PLANNING AND ZONING Cerro Gordo County Courthouse

Staff Report Board of Adjustment Variance Request August 25, 2026

Case No.: 26-07

Request: A variance request to construct an upper-level deck over the existing lower-level deck on the rear (lakeside) of the dwelling with an east side yard setback of 1.4'. A 3' side yard setback is required.

Site Drawing:

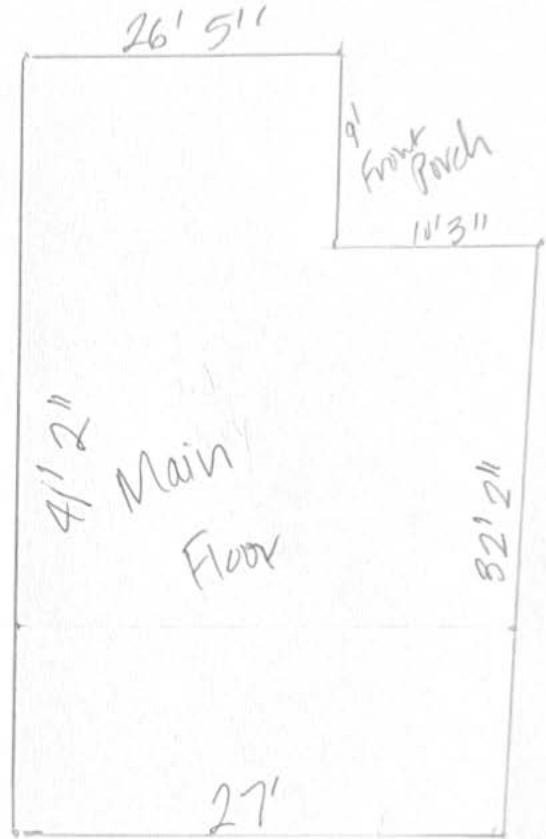
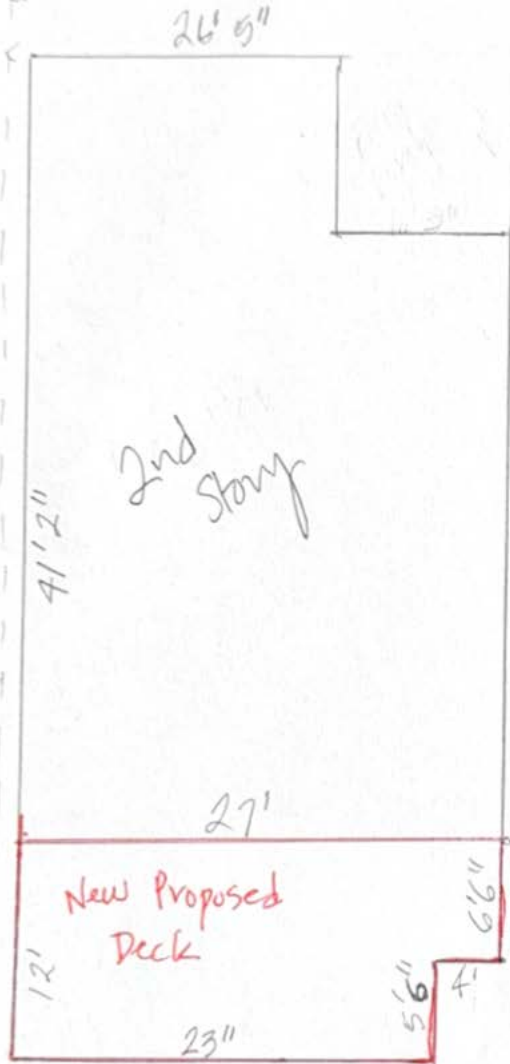
The proposed upper-level deck would be approximately 1.4 feet from the east side lot line and therefore would not comply with the 3-foot minimum setback required by Article 6.28(B).

Because the existing lower-level deck would be enclosed with screening, it would be treated as an enclosed deck or porch and would be subject to the full 6-foot side yard setback. The proposed screened enclosure would also be approximately 1.4 feet from the east side lot line. The zoning permit application was denied on July 6, 2026. The owner submitted a variance application on July 14, 2026.

However, Article 6.28(B) specifically permits open decks on lake lots to encroach into a required side yard only to a defined limit. The proposed upper-level deck would be 1.4 feet from the east lot line, where 3 feet is required. It would therefore extend 1.6 feet beyond the encroachment already permitted by the lesser Ordinance standard.

The screened lower-level enclosure presents a greater deviation. It would be 1.4 feet from the lot line, where 6 feet is required, resulting in a 4.6-foot deviation. Granting that request would allow an enclosed or screened structure to occupy most of the required side yard.
